September 17, 2021

**GS# 114-023 Science Bldg. Infiltration Repairs**  
**University of Southern Mississippi – Gulf Park Campus**  
**Long Beach, MS**

### Addendum No. 3

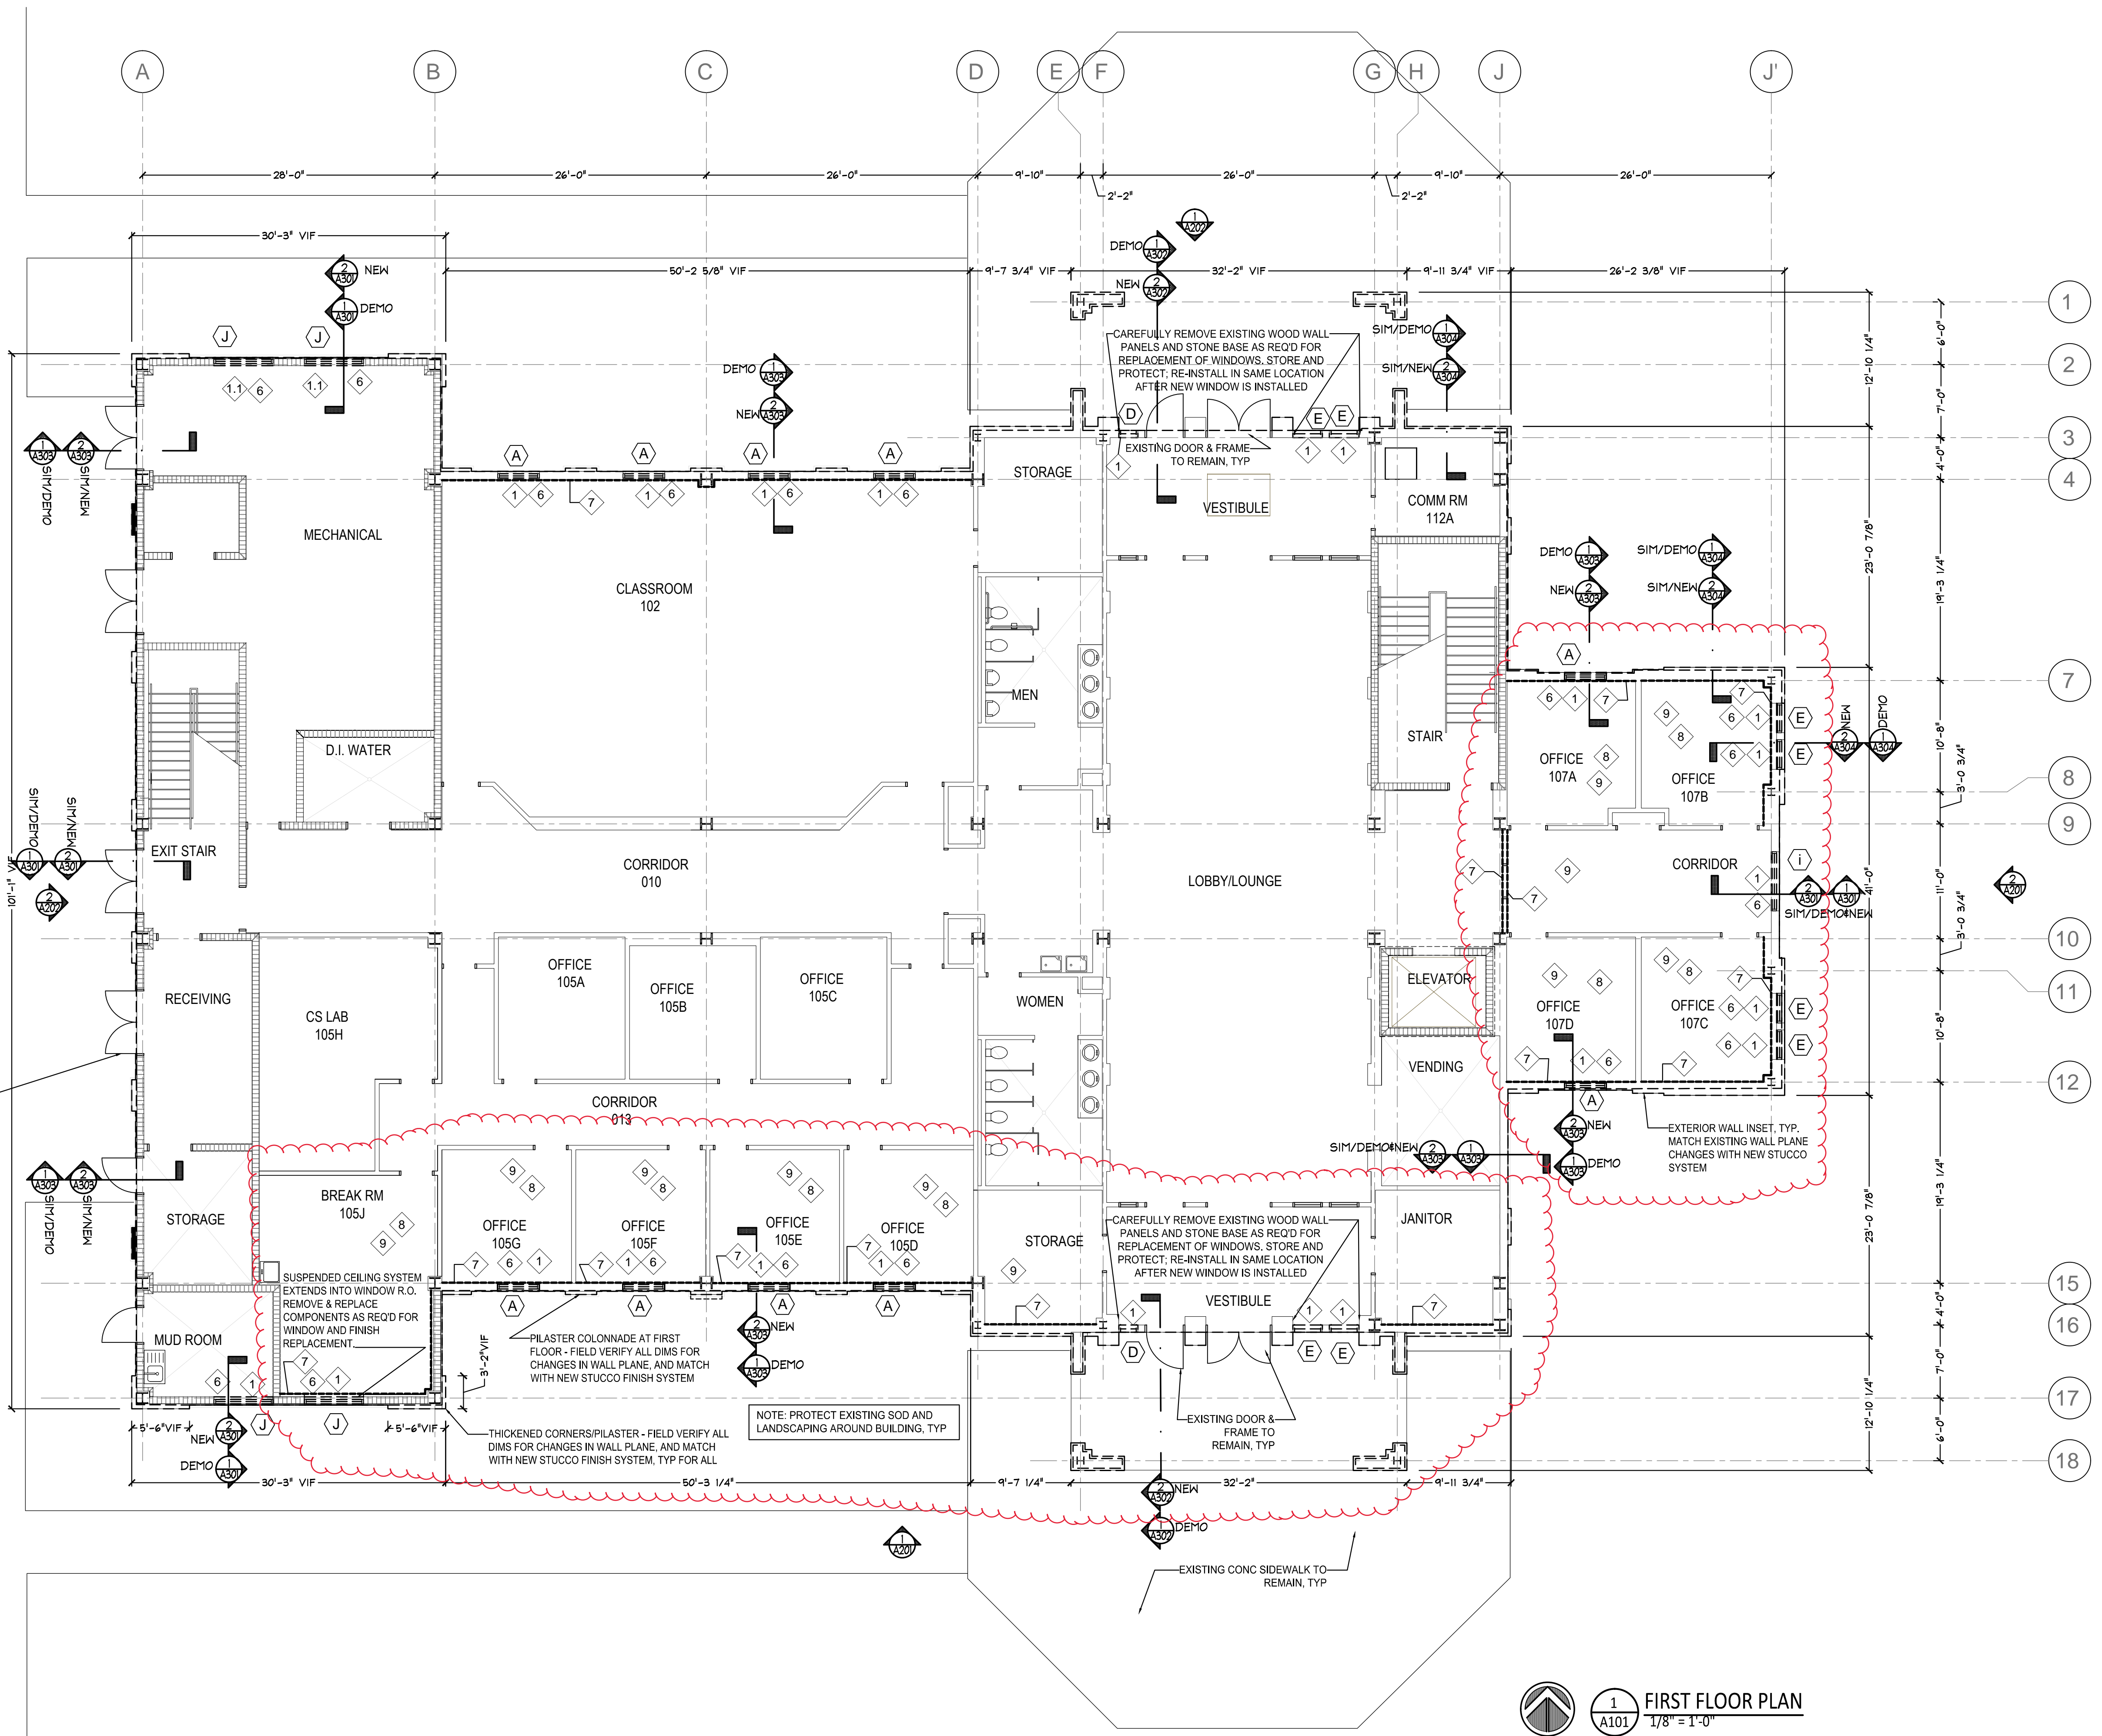
- a. First floor: Additional exterior wall gypsum and batt insulation replacement, interior finish replacement in office areas 105D, 105E, 105F, 105G, 105J, 107A, 107B, 107C, 107D, corridor. See attached revised sheet A101.

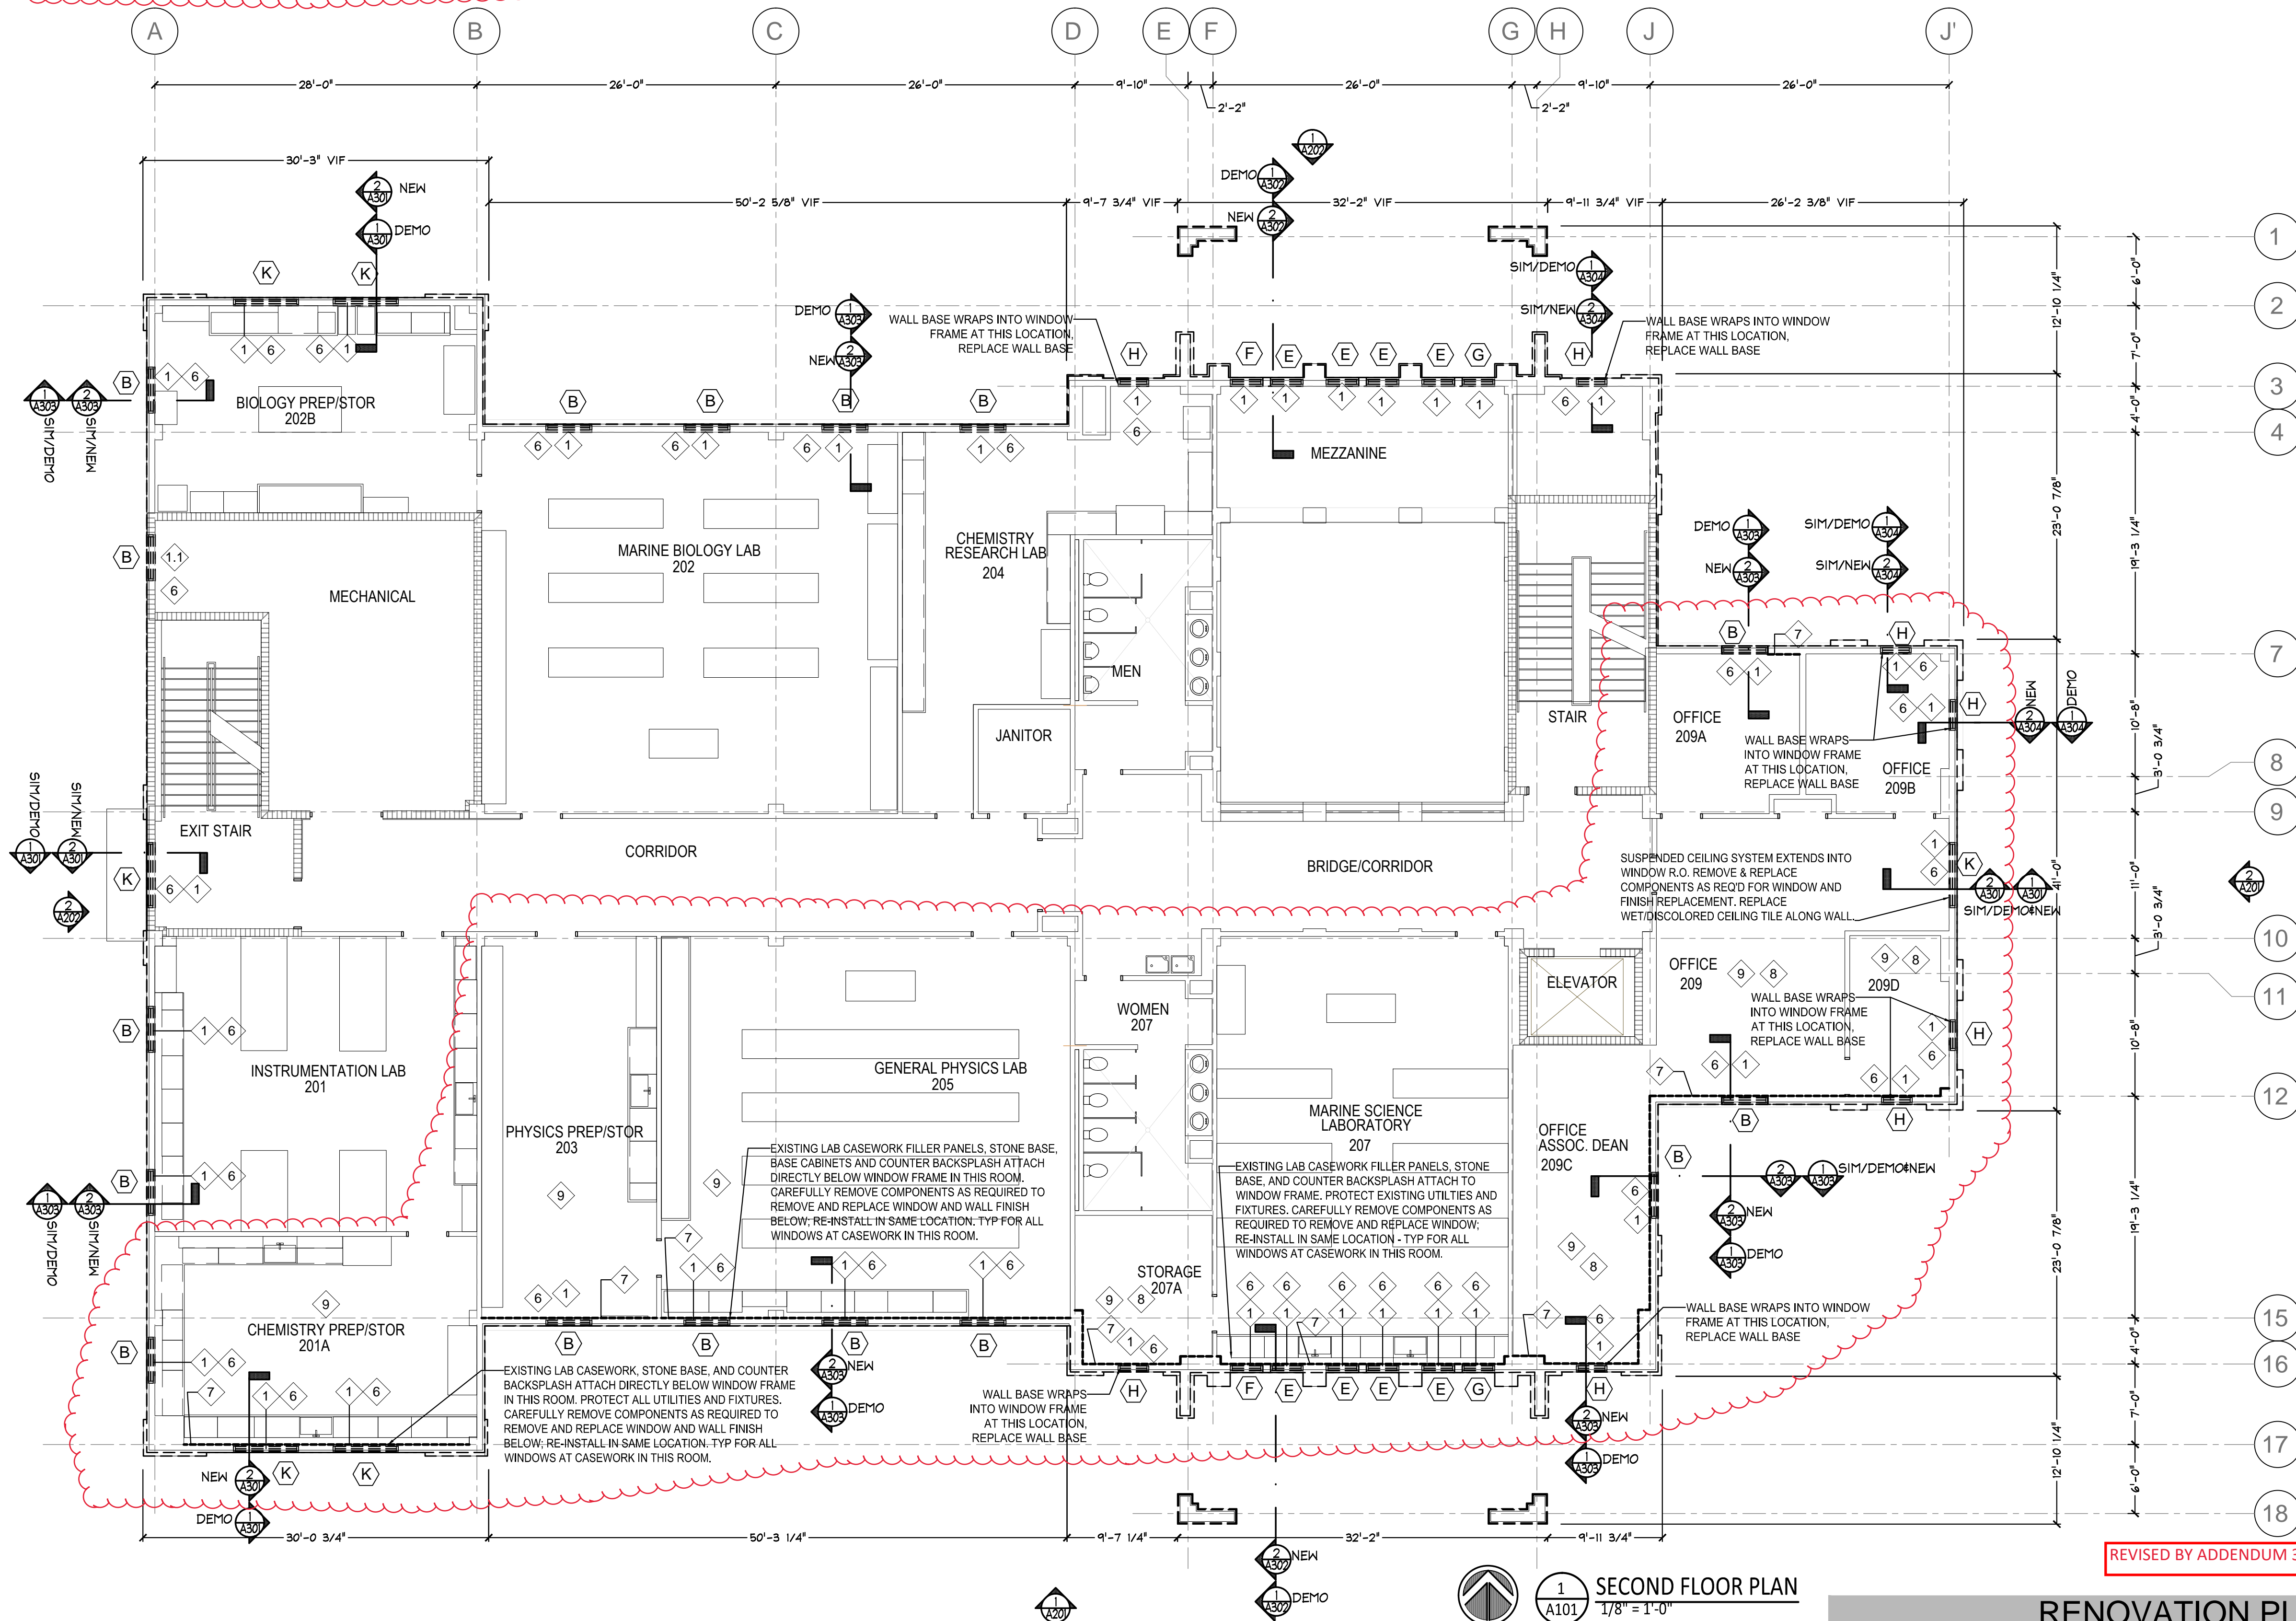
- b. Second floor: Additional exterior wall gypsum and batt insulation replacement, interior finish replacement in all areas along Southern wall – 201A, 203, 205, 207A, 207, 209C, 209, 209D. See attached revised sheet A102.

SHEET  
A103R  
SZZARCH#  
DRAWN BY: SZ  
CHECKED BY: SZ  
DATE: 09-17-2021

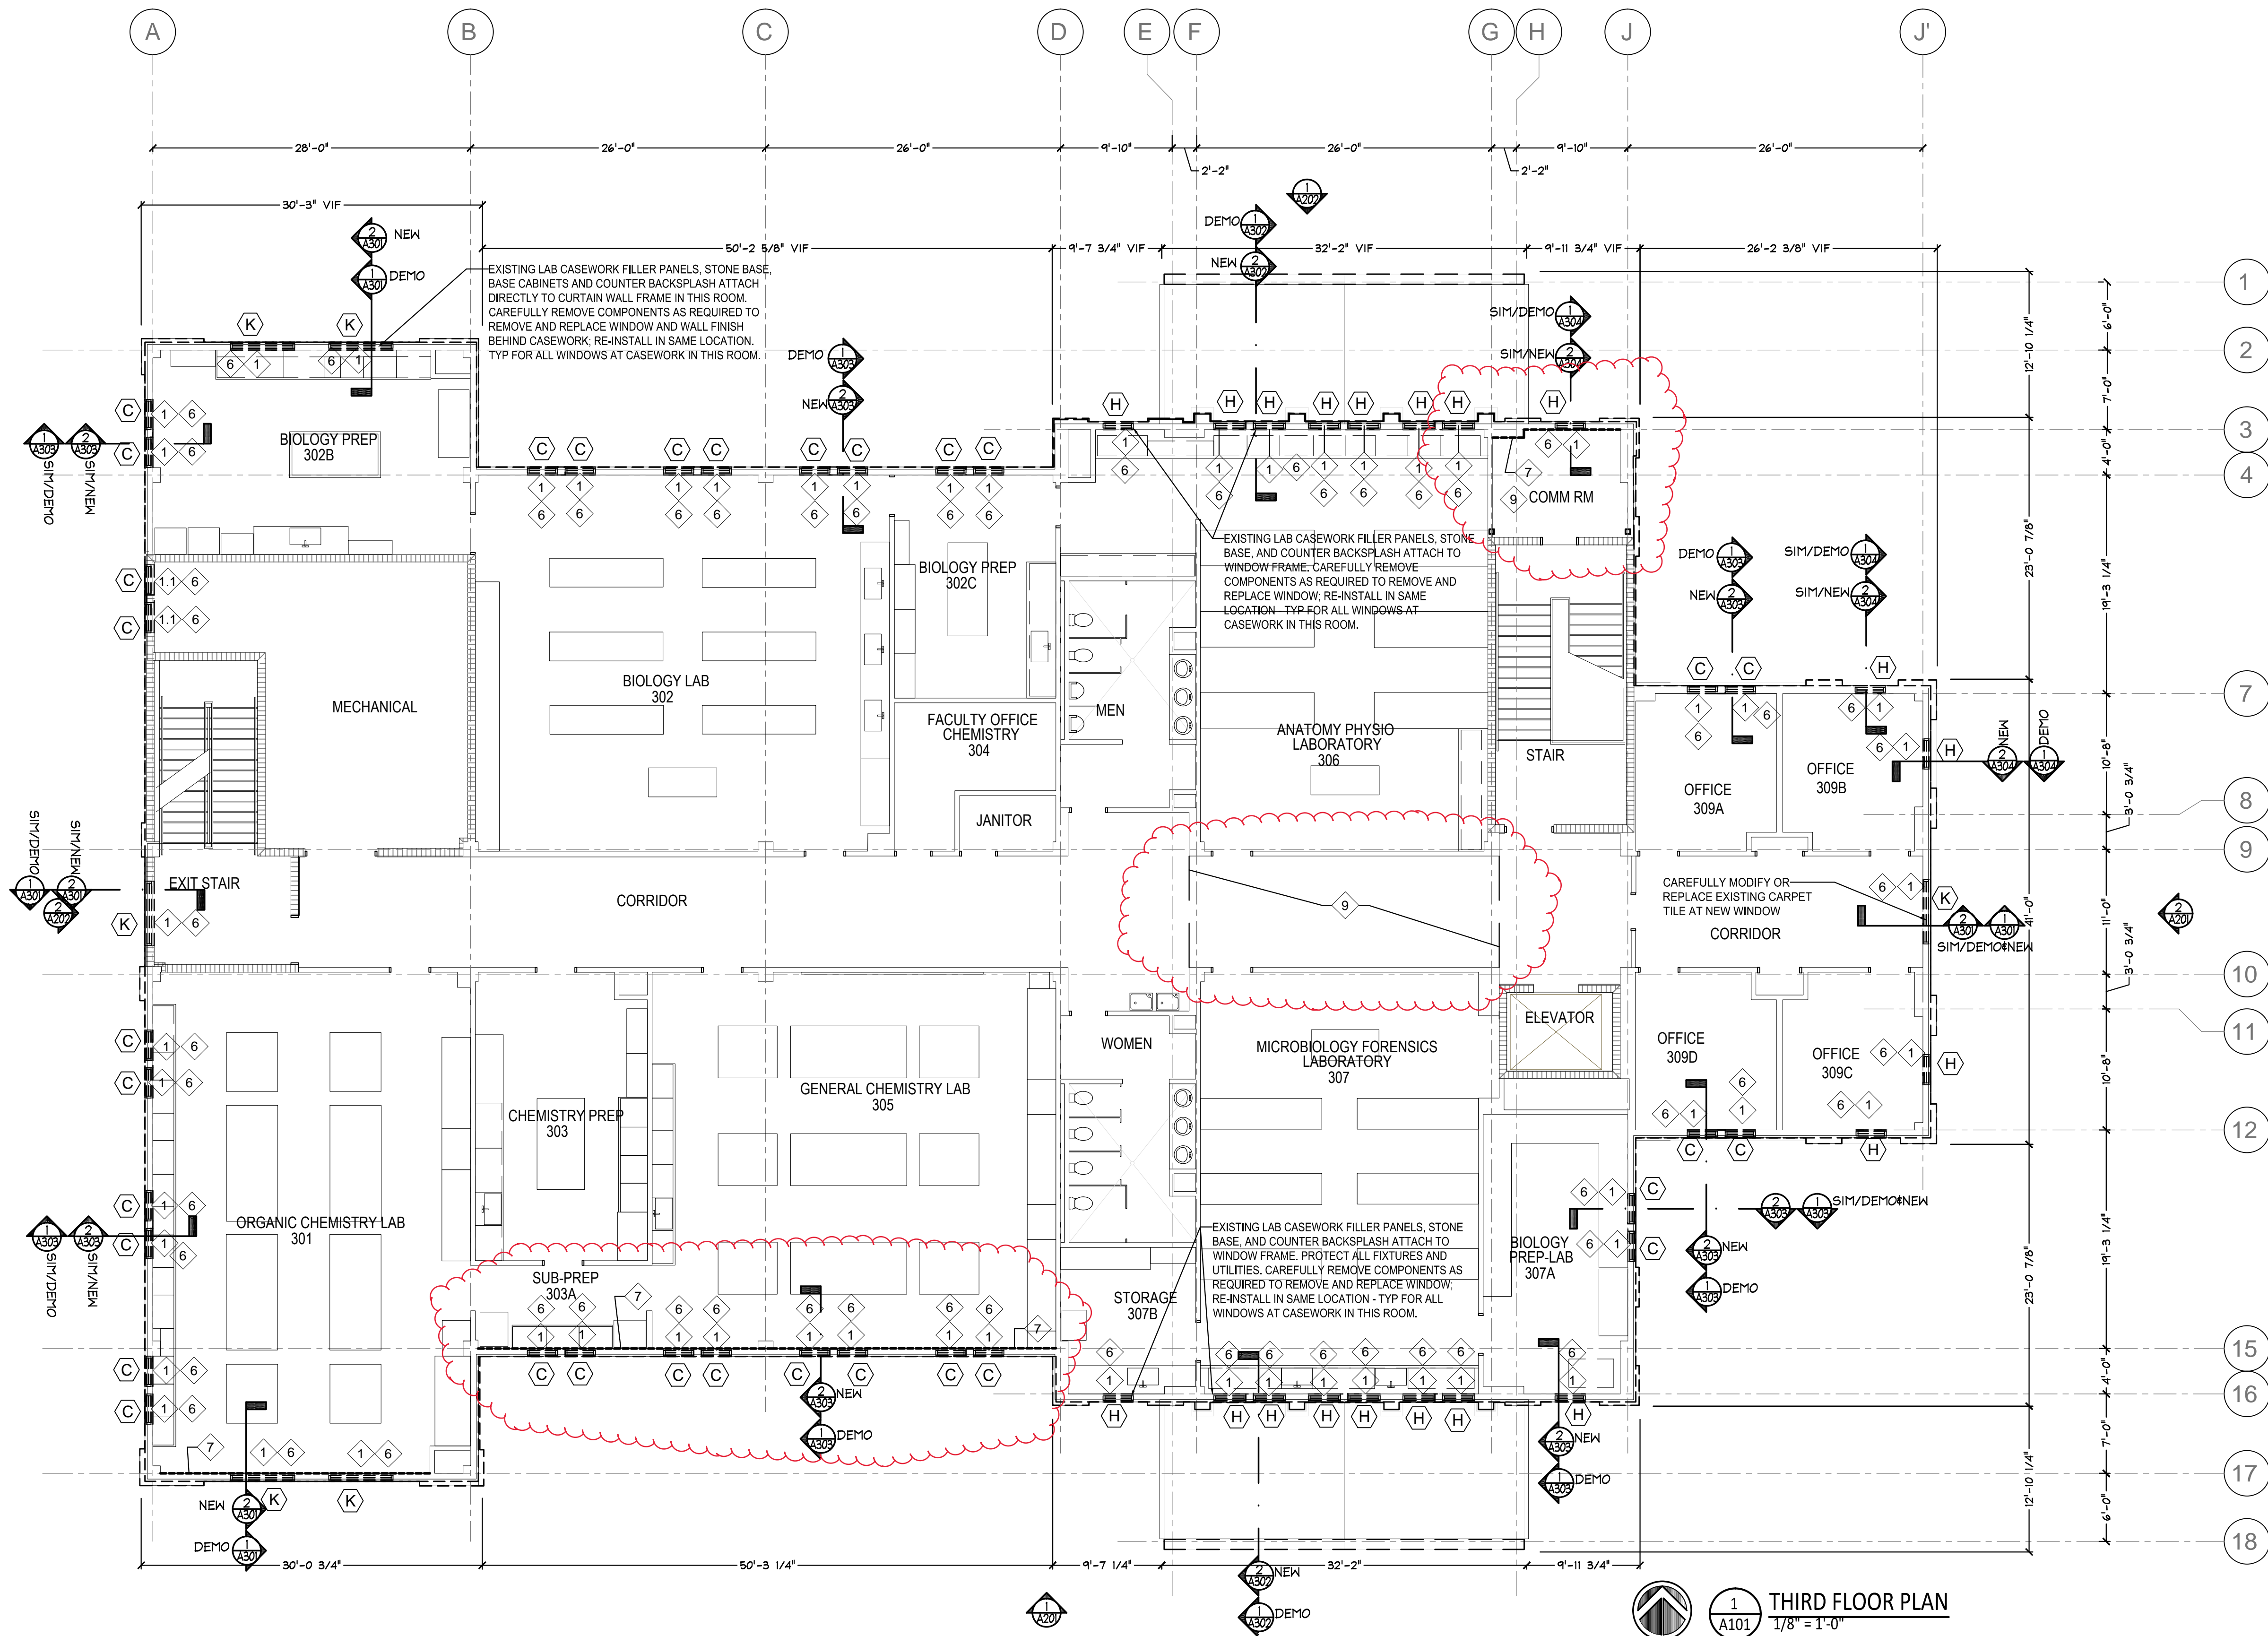
- c. Third floor: Additional exterior wall gypsum and batt insulation replacement, interior finish replacement in 303A, 305, COMM RM, CORRIDOR area between 306 and 307. See attached revised sheet A103.
